BURLINGTON DEVELOPMENT REVIEW BOARD

Tuesday, January 4, 2022, 5:00 PM

MEMORANDUM

To: Development Review Board
From: Mary O'Neil, AICP, Principal Planner
Date: January 4, 2022
RE: ZP21-762 22 Park Street

22 Park Street
Garage
Rolf Danielson
12/16/2021

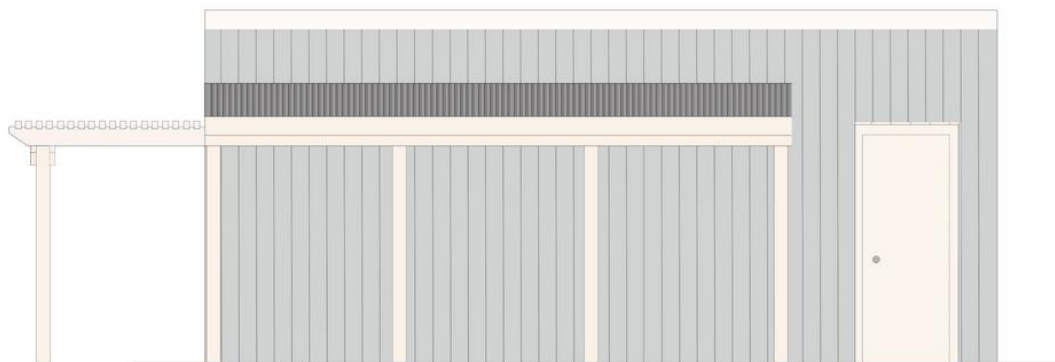
Request: 5 bedroom Bed and Breakfast; 2 bedrooms (Unit 3) and 3 bedrooms (Unit 4). Modify west elevation of garage to add new vehicular opening and move pedestrian door to north elevation. 9 parking spaces on site.

There is nothing within the application that includes a change to the existing residential structure. The garage entrance will be altered for a second vehicular entry. The use application will provide living space for guests on a short term basis. The less-than-30 day rental is not expected to generate nuisance impacts from noise, odor, dust, or similar. **Affirmative finding.**

Updated Parking Plan

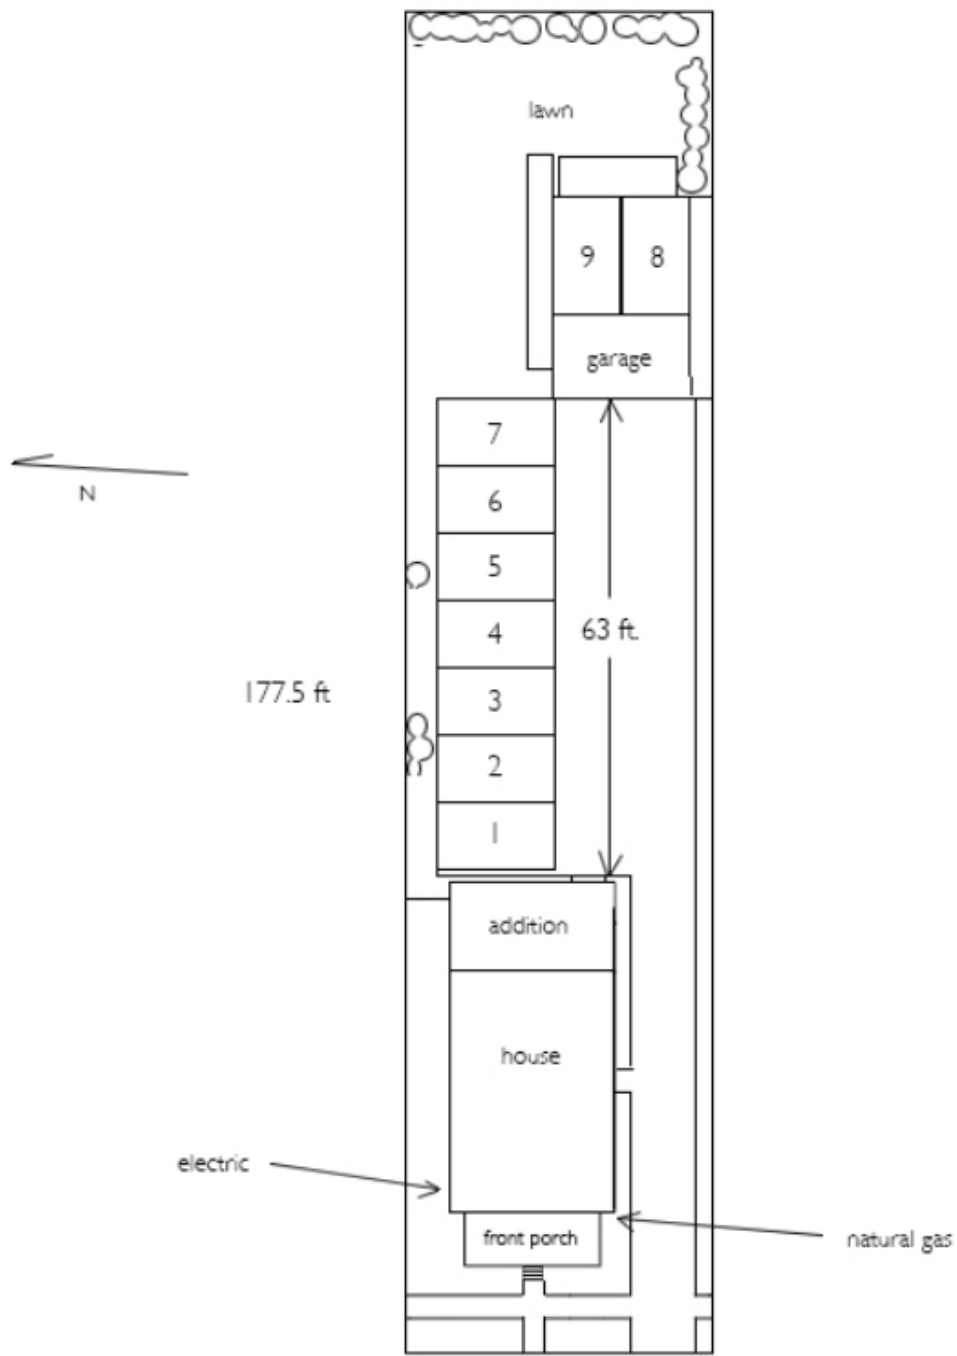
22 Park Street is an existing four-unit residential building. No exterior changes are included in this application. A previous approval included 8 parking spaces behind the building. The applicant has offered to accommodate the additional required parking space (1 per bedroom + 2 for each remaining unit) within the existing garage, for a total of 9 spaces. The applicant will modify the west elevation of the garage to provide two vehicular entries.

4-400 | WEST ELEVATION

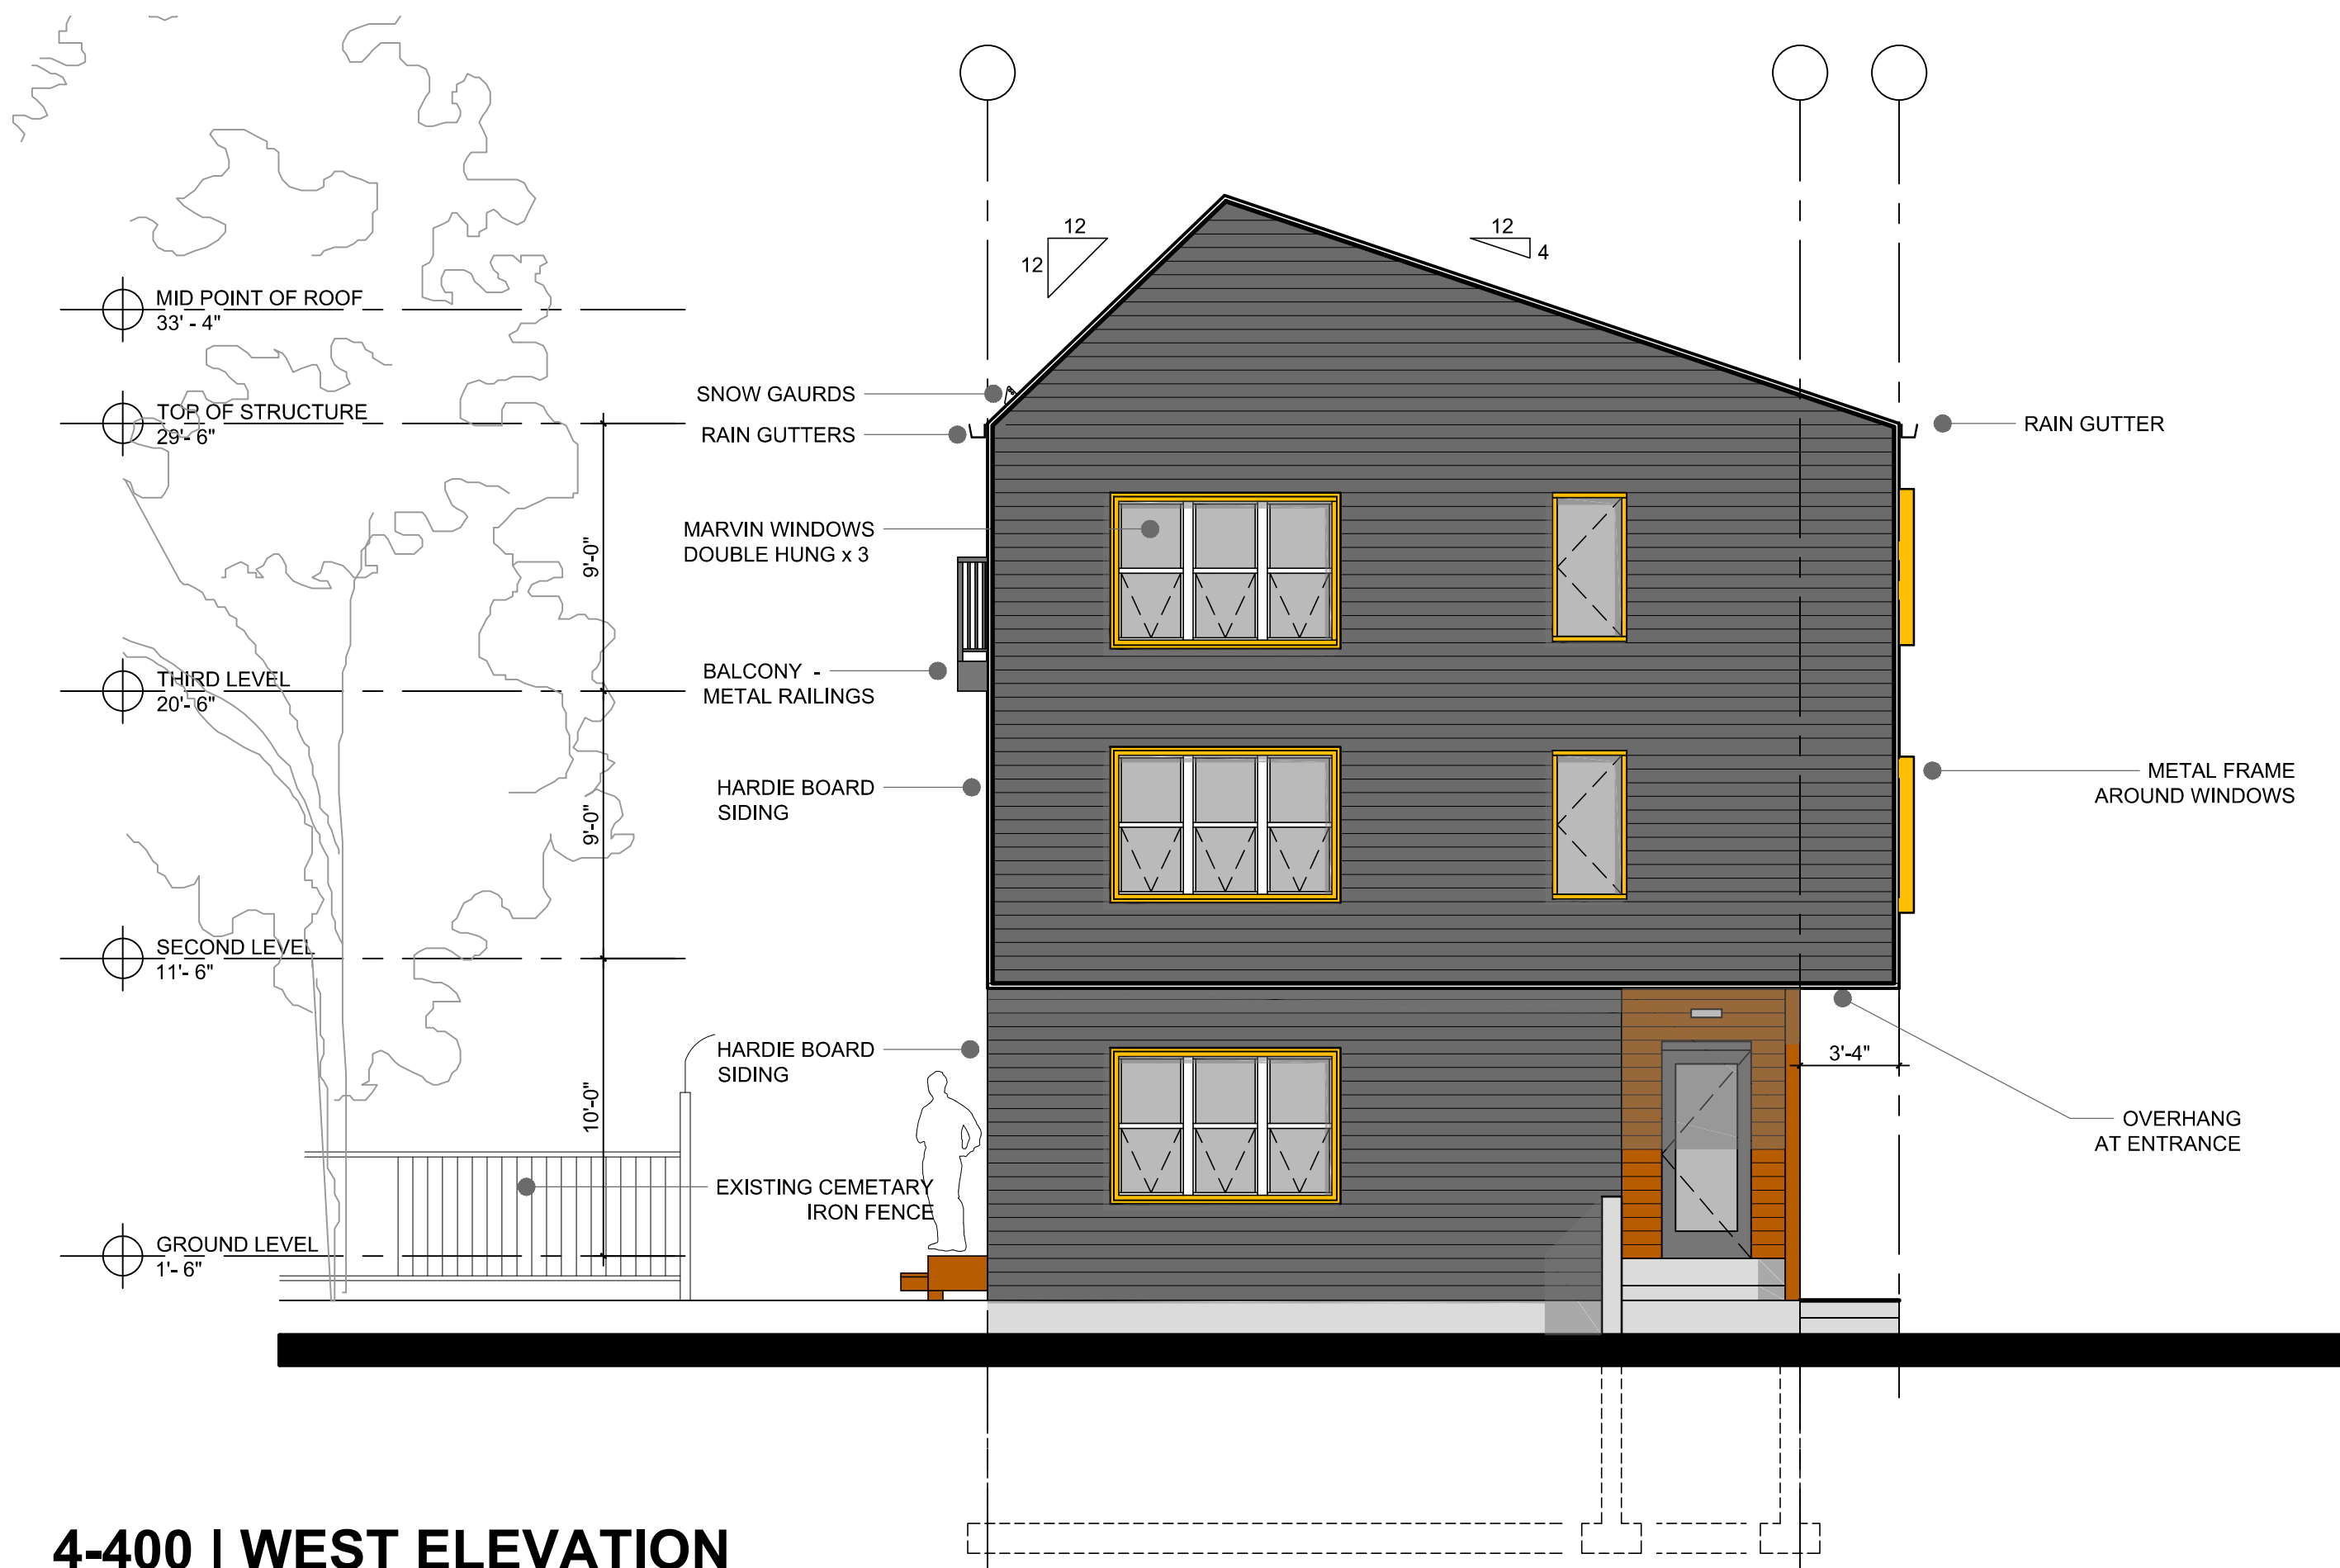
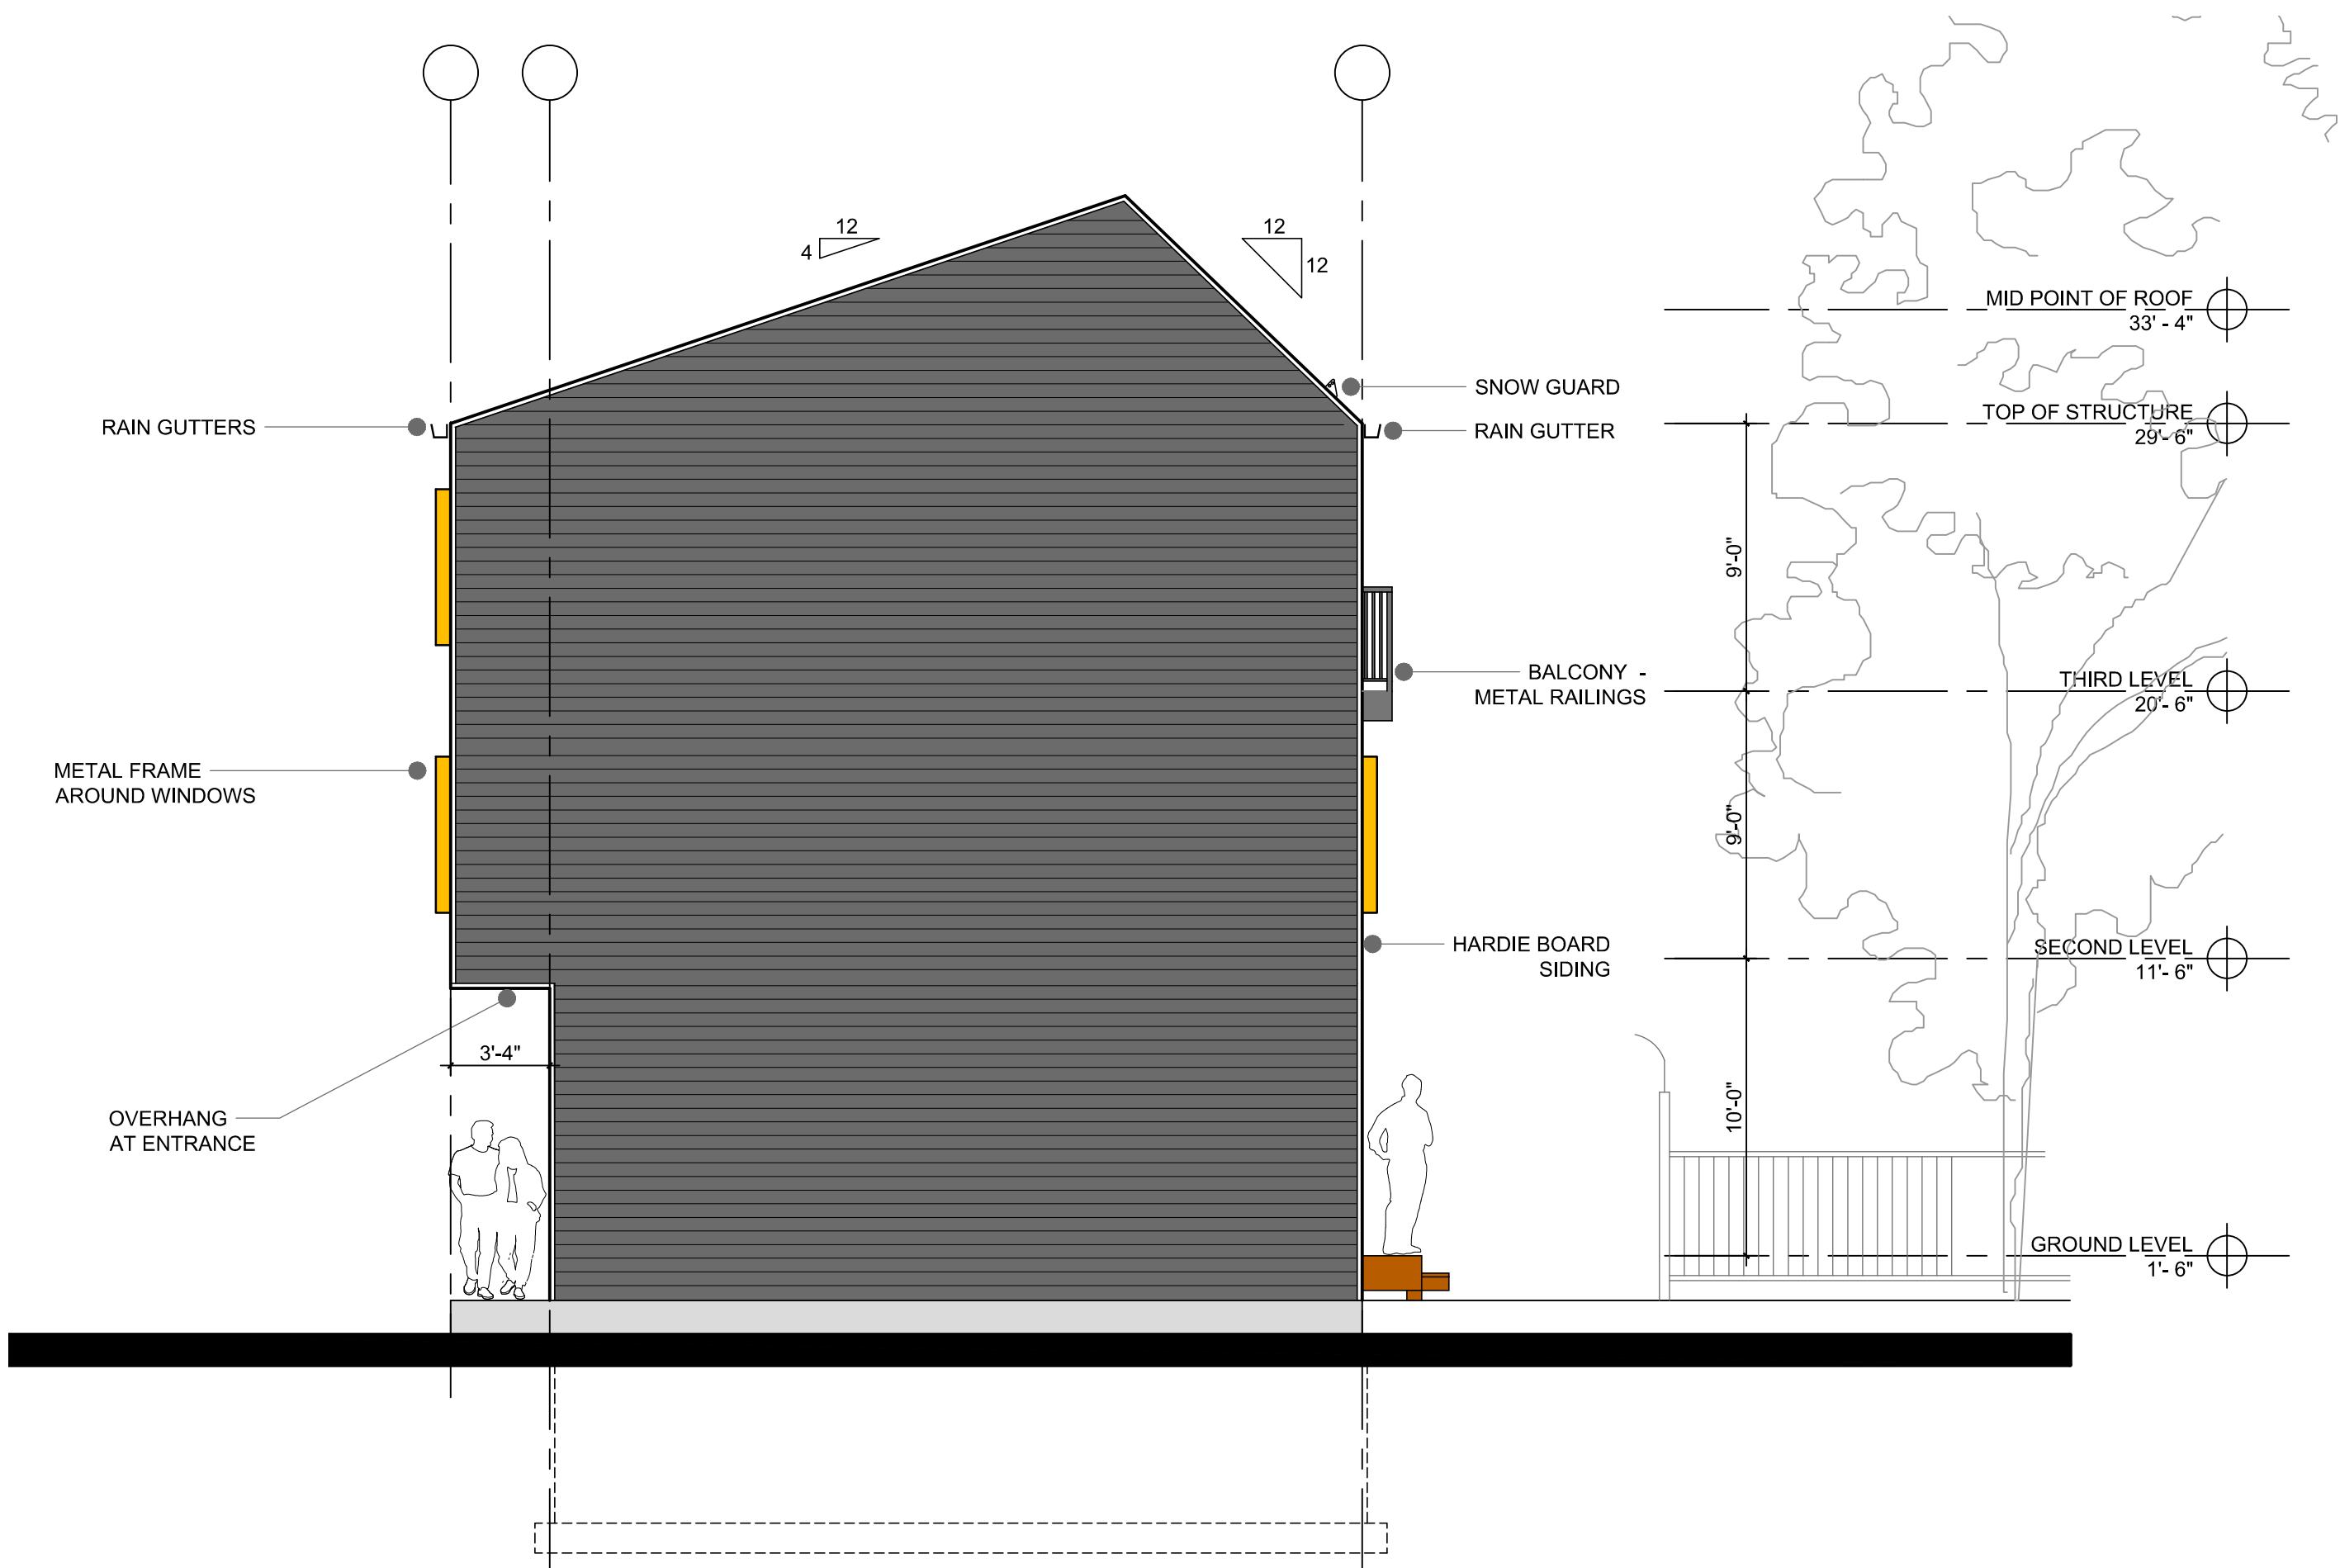
The proposed building has a modified cat-slide roof with dual pitch and minimal eave extrusion. Responding to DAB comments, snow guards and rain gutters have been added on the north and south elevations. In style it reads as a modern infill. **Affirmative finding.**

As designed, the building lacks typical façade articulation such as bays, horizontal and vertical façade articulation, porches, patios, articulated bases, step-backs or other street level details. Upon the recommendation of the DAB, a change in plane and color has been introduced between the first and second floor. Windows are stacked, providing a measure of arrangement. The plan is modernistic with a simplified form and measured detailing. The most prominent design component is the angular and asymmetrical roof line, and “framed” window surrounds. Revisions include a differentiated first floor south and west entry, as requested by the Design Advisory Board. **Affirmative finding.**

Plans include fiber cement siding, with metal frame surrounds on windows and an asphalt shingle roof. All are considered acceptable for new construction. **Affirmative finding.**
